SERVICE BULLETIN

TITLE: FLAP PRESELECT CONTROL CABLE - REPLACEMENT

NUMBER: SI09-82 Series-1

Cessna 414A Aircraft Modified by STC SA892NW

Figure 2 Preselect Cable Forward Mount Relocation

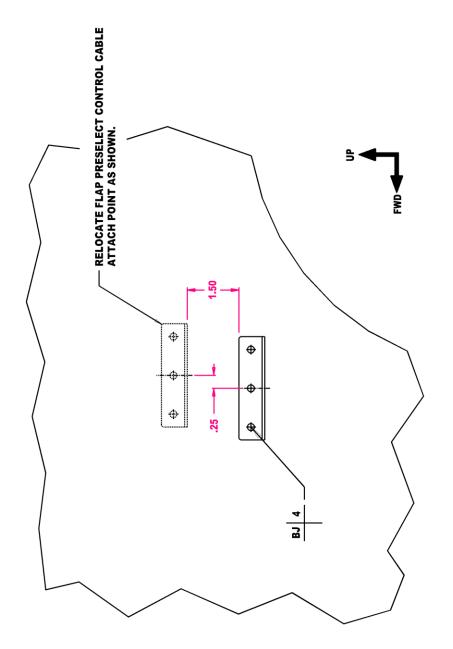
Relocate flap preselect control cable forward attach point per Figure 2, reinstall using MS20470AD4 rivets. Remove 82-801-1 Arm Assembly from Flap Selector Handle Assembly and retain hardware. Install 82-801-2 Arm Assembly using retained hardware per Figure 3. Trim upper portion of console as required to clear 82-801-2 Arm Assembly thru range of motion. Fill existing unused holes with MS20470AD4 rivets.

igure 3 Flap Selector Handle Assembly

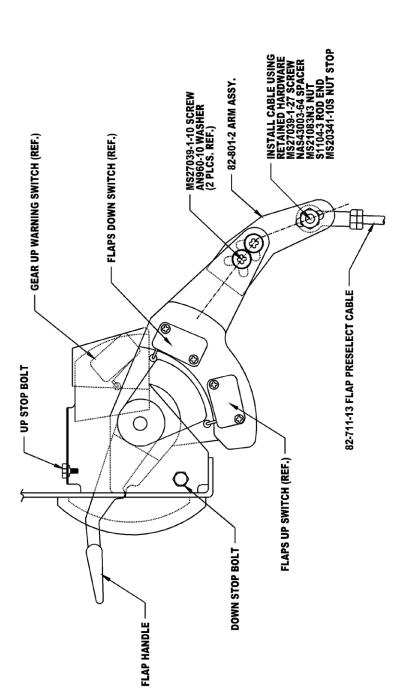
- 20. Adjust the lower flap selector handle stop so that it stops the flap selector handle at the same time the handle contacts the lower edge of the cutout in the instrument panel, see Figure 3.

- 23. If the flap selector handle UP stop bolt runs out of adjustment travel, the rate of the flap selector switch assembly will have to be adjusted, see Figure 3.

- 24. This is accomplished by adjusting the rod end at the forward end of the flap preselect control cable in the slot in the 82-801-2 extension arm on the flap selector switch assembly.
